CERTIFICATE OF APPROPRIATENESS

Property: 412 Main Street Tracts 2A and 3A, Block 44, SSBB Subdivision, City of Houston, Harris County, Texas. The site includes a 13-story steel frame building situated on a 4,626 square foot lot.

Proposal: Alteration – Remove the existing historic, heavily damaged cornice above the 12th floor and replace it with smooth EIFS scored to look like masonry.

412 Main Street East Facade Repairs

EAST ELEVATION – FRONT FACING MAIN STREET

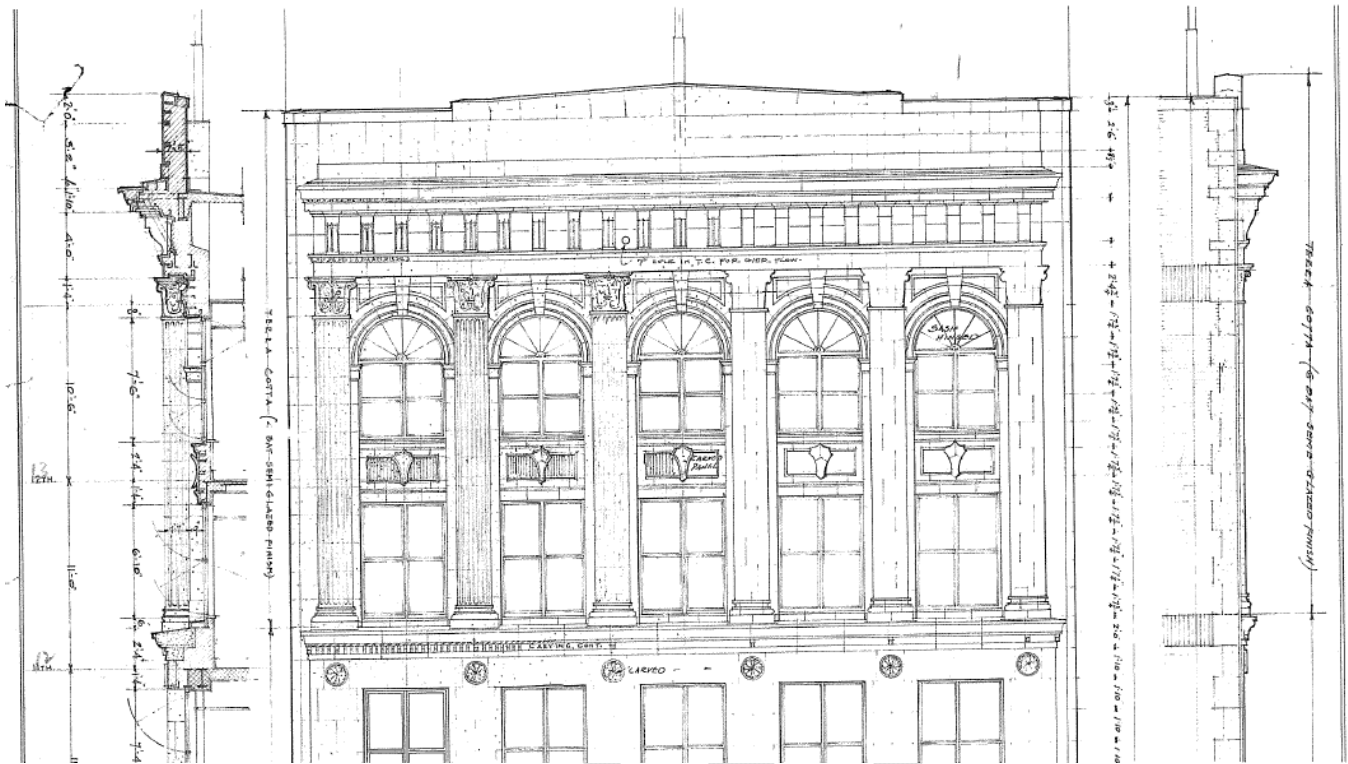
PROPOSED EIFS SCORING

PORTION TO BE REMOVED

ORIGINAL DRAWING TO USE FOR REFERENCE

Corroded reinforcing steel at front edge of soffit

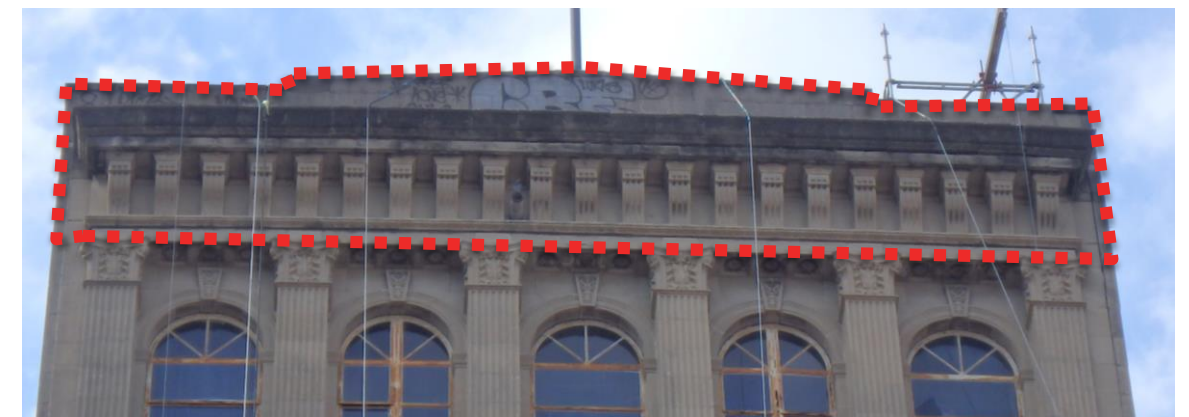
- Exploratory openings exposed severely corroded reinforcing steel bars at the root of the lower cornice front face sections exhibiting cracking and spalling.
- Exploratory openings were not performed at the soffit cracking of the lower cornice cast stone distress due to structural and fall hazards concerns. This cracking is likely due to the presence of corroding embedded reinforcement; however, the distress may be the result of restraint cracking induced by the corbel movement.

Extents of proposed repair

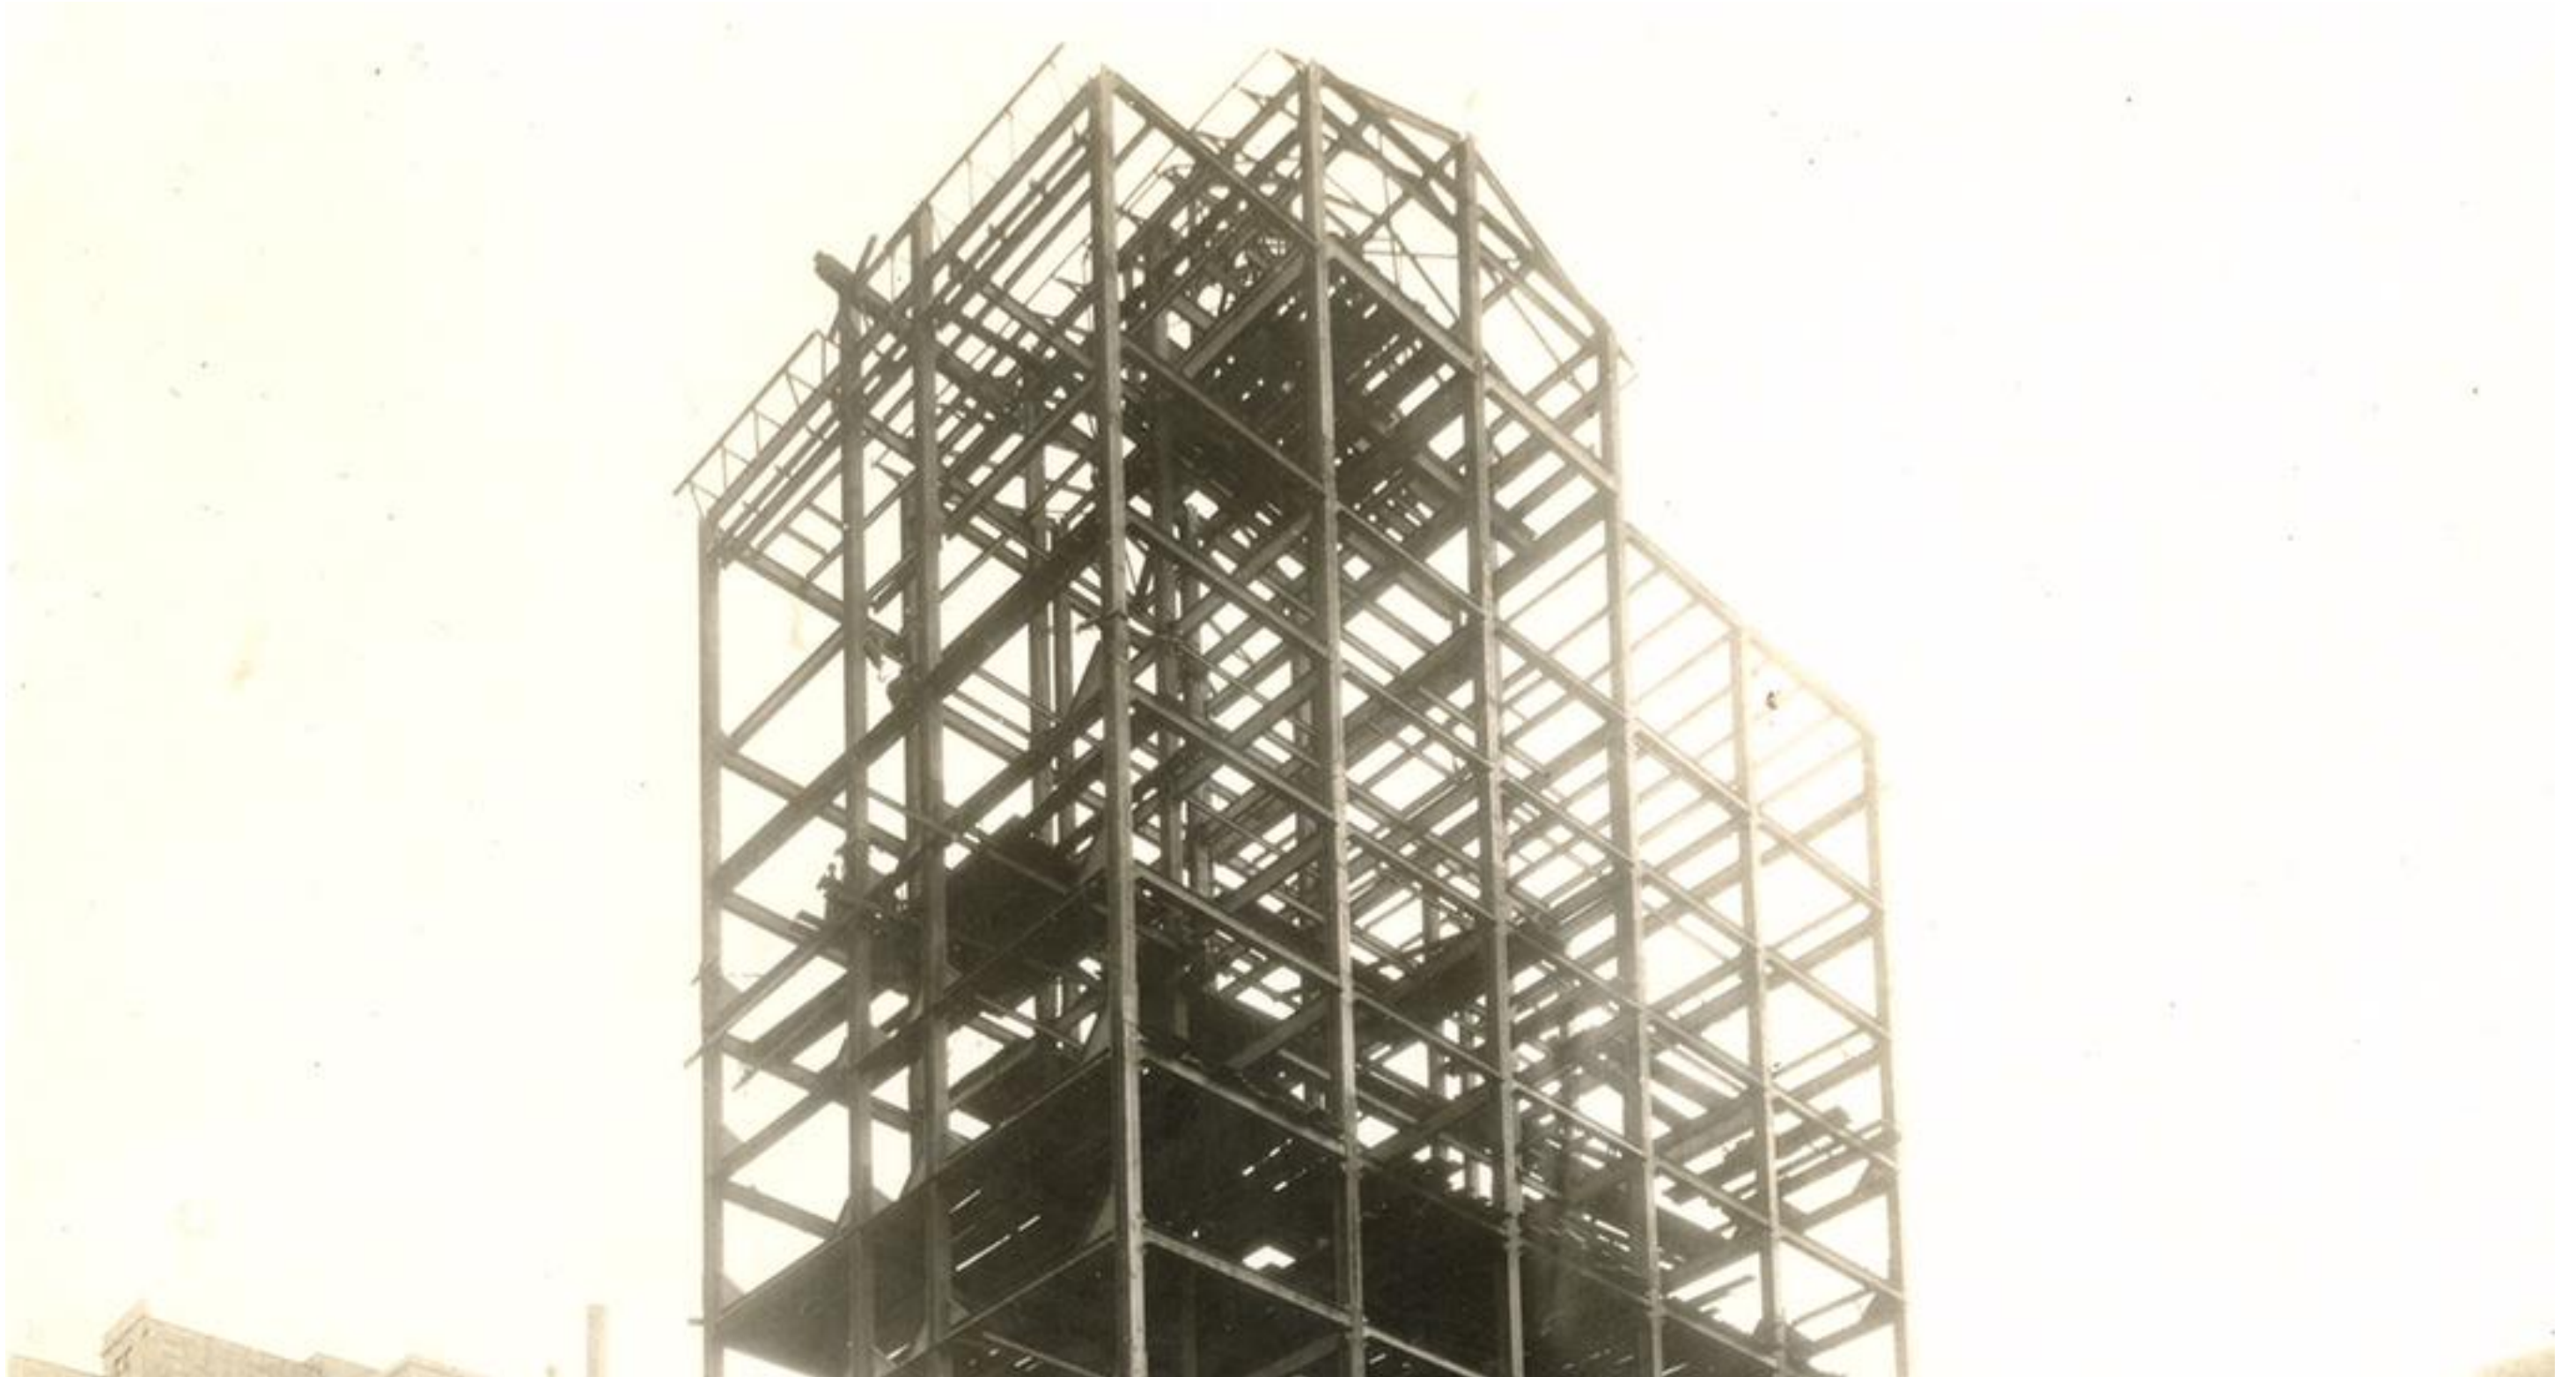
- Extents of repair limited to east facade, from top of parapet to the soffit of the lower cornice.
- Repair concept requires approval of the Houston Archaeological And Historical Commission (HAHC).
- A lightweight parapet façade recladding system is proposed to minimize loading onto the existing structure.
 - New Structure: New steel framing to connect to the into existing interior steel frame.
 - Existing Structure: Clean, epoxy/intumescent coat, and strengthen or replace as required.
 - Facade: Exterior Insulation and Finishing System (EIFS) with common bond mortar joint engraving to generally replicate existing cast stone parapet pattern.

Proposed Schematic Parapet and Cornice Repair

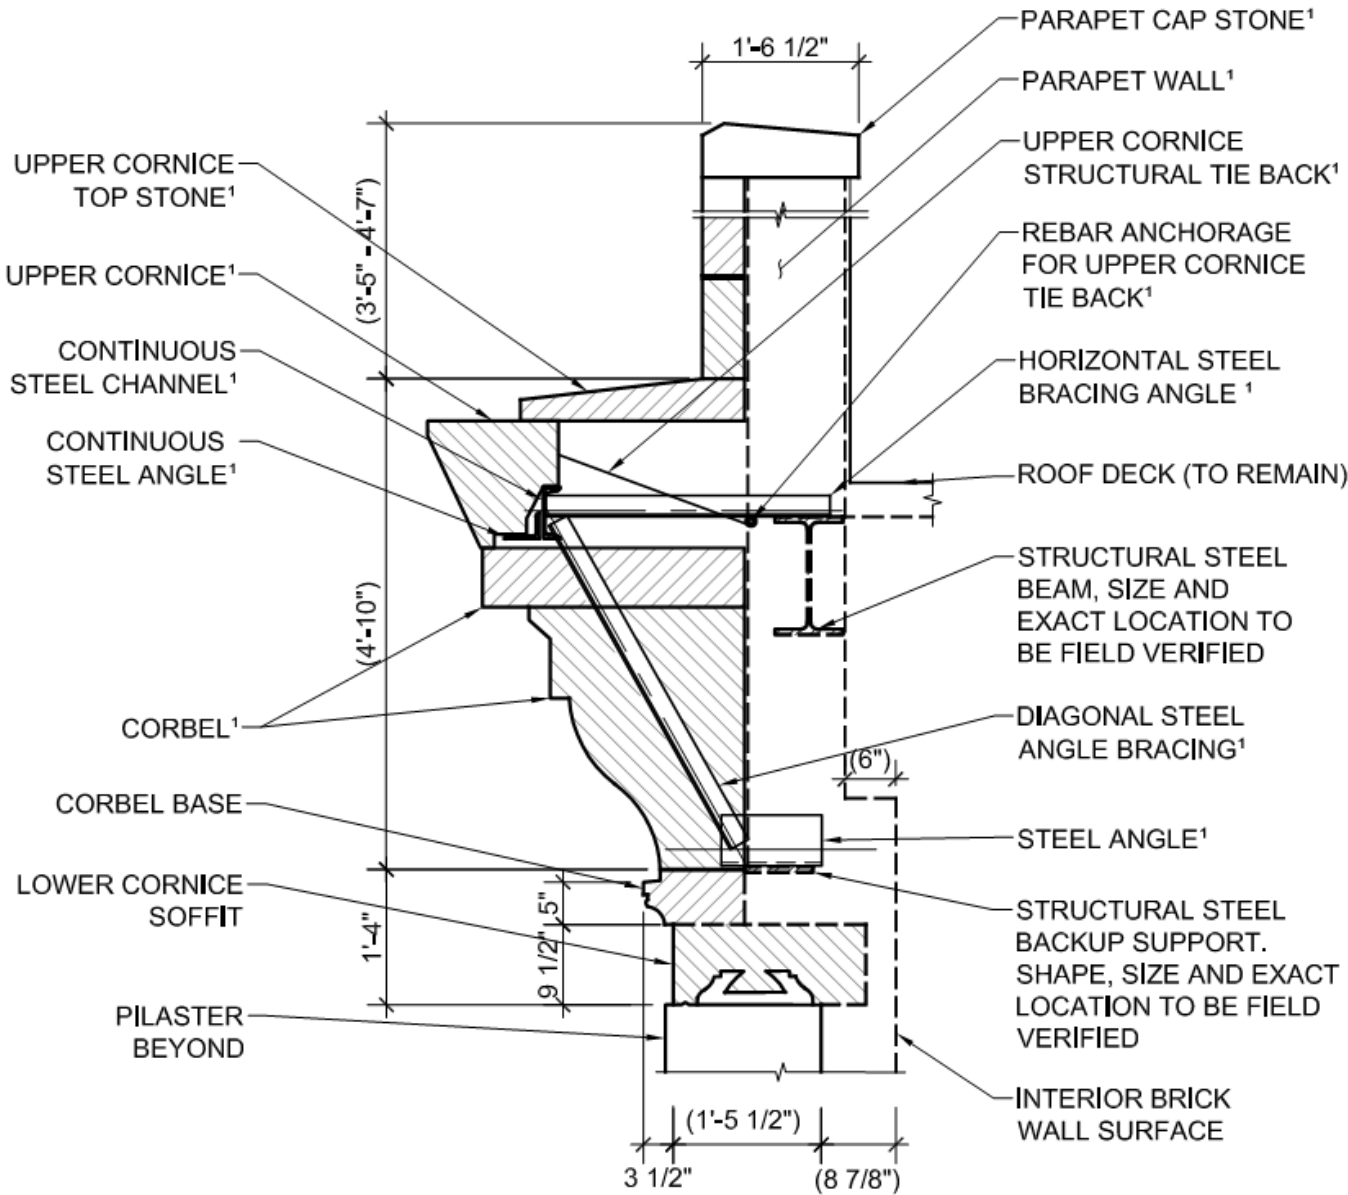
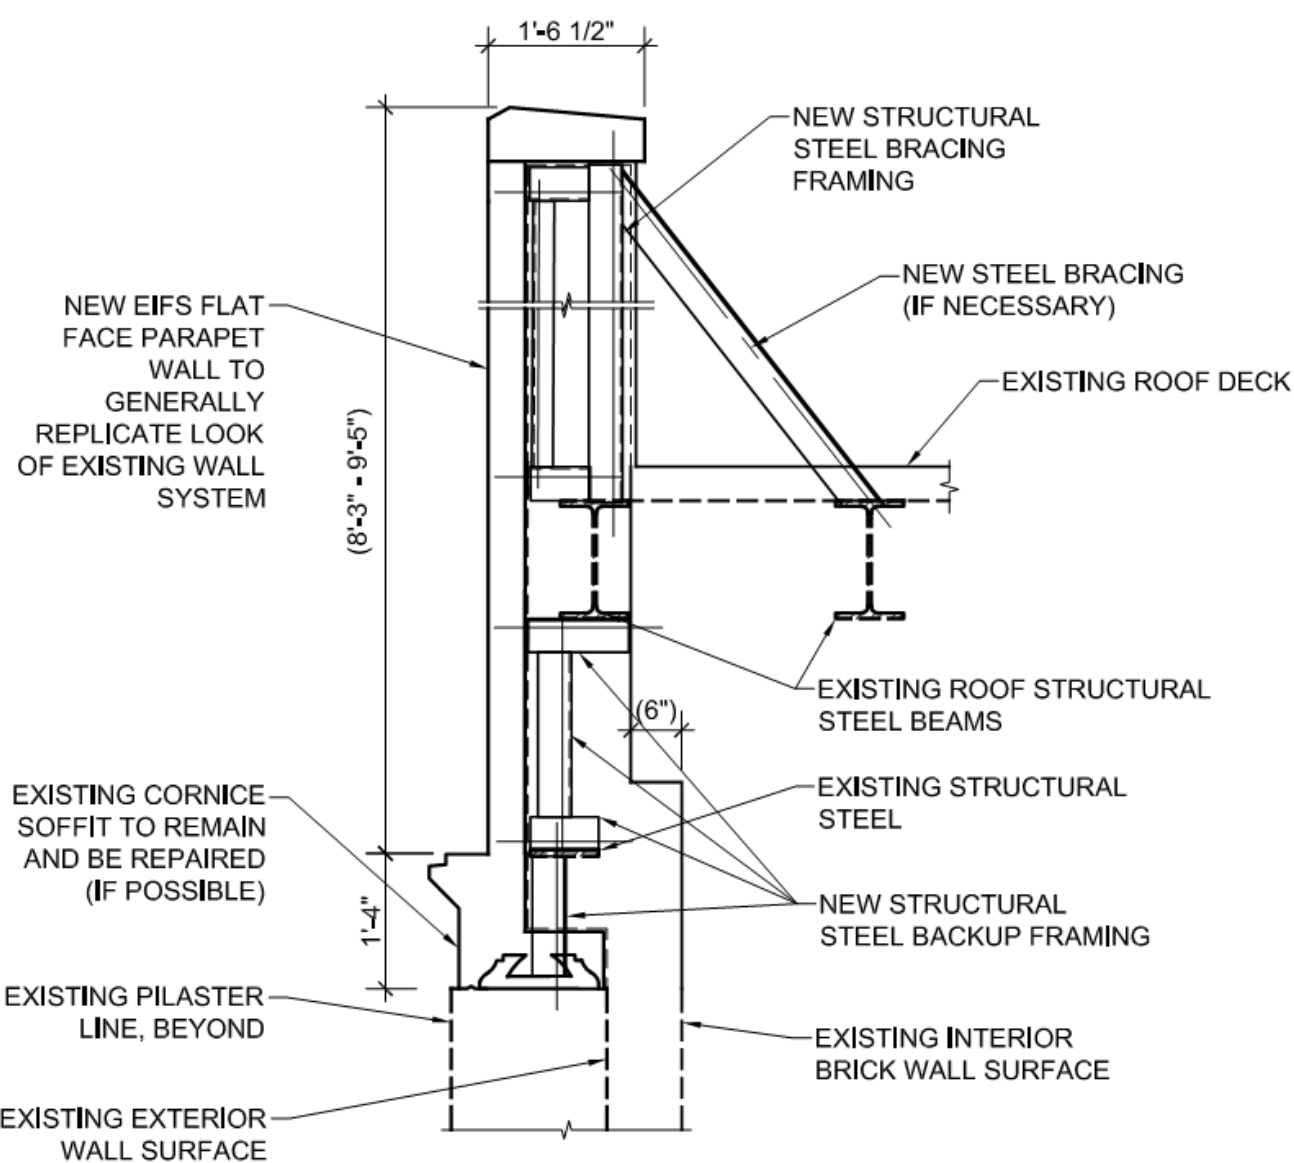
NOTES: 1. THIS ITEM TO BE REMOVED AND DISCARDED.

EXISTING FRONT WALL SECTION,
SCHEMATICALLY SHOWN

PROPOSED FRONT WALL SECTION,
SCHEMATICLY SHOWN
